Public Consultation Report – Full Version

Comrie Flood Protection Scheme

Perth & Kinross Council

November 2019

*Figure 3 – Revised outline design of boulevard area
(including removal of pedestrian access ramp)*

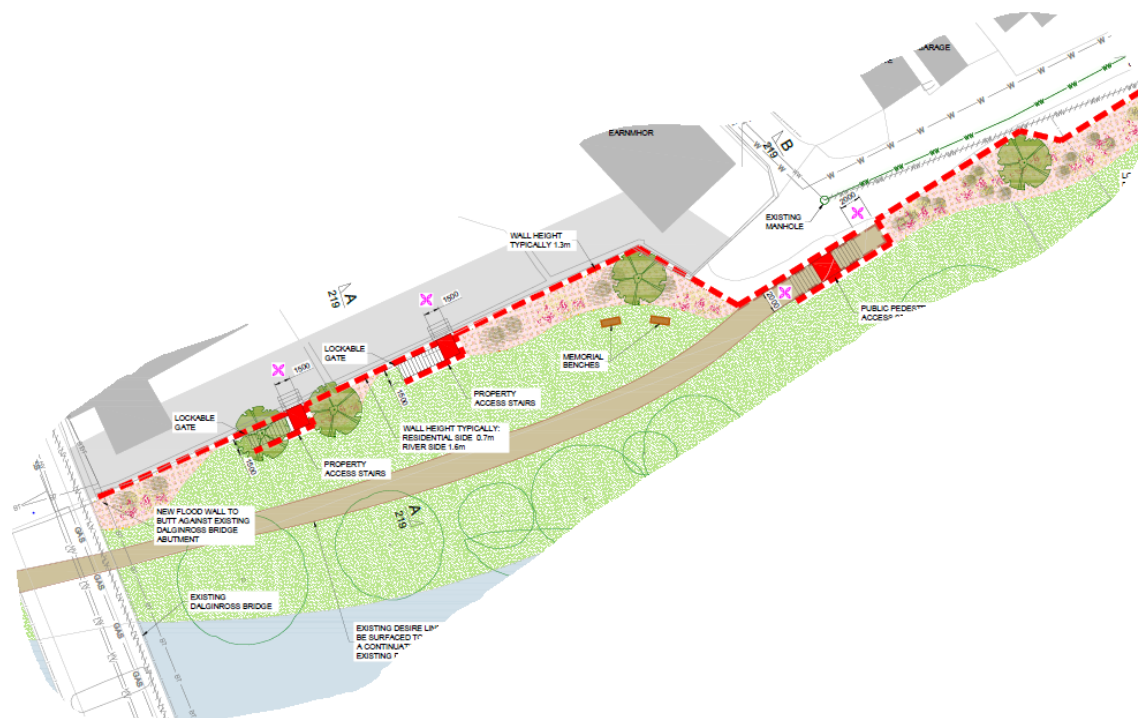
Ramps were proposed in the outline design to provide access over the flood wall. However, some consultation responses noted these were felt to be intrusive and cited a preference for flood gates in the area as an alternative.

Some respondents stated that if access ramps must be provided in this area, that there would be a strong preference to have them as hidden from view as possible or to have them located elsewhere.

Access requirements for wheelchair users were also highlighted, including the potential problems associated with unsurfaced paths.

It was also noted that this area is currently used as an event space; particularly in the summer during the Comrie Fortnight and that the flood scheme proposals would potentially affect access to the associated events.

The Council has noted from the responses received that the proposed access provision in this location was not popular with local residents. The design has therefore been amended in the boulevard area in a number of ways. The visual impact and land take have been reduced by:

1. Removing the 1:20 pedestrian access ramp that had been proposed at **Commercial Lane** and relocating it elsewhere; and
2. Removing the road access hump proposed at **Ancaster Lane**.

The removal of the pedestrian access ramp originally proposed at this location has meant that the Council has had to seek an alternative way to maintain access to the riverbank for those with mobility issues. The Council's revised proposal is to use the existing access from Bridge Street located at the west side of Dalginross Bridge. There is already an existing ramped access here but it is too steep for some people to use in its current form. This area will therefore be altered and re-landscaped to improve access for wheelchairs, bikes and buggies to the riverbank and the boulevard area.

The proposals still include a stepped pedestrian access at the bottom of Commercial Lane but this has been relocated further away from adjacent properties to help reduce its visual impact. This will also maintain the privacy of those properties by ensuring that they won't be overlooked by those using the steps.
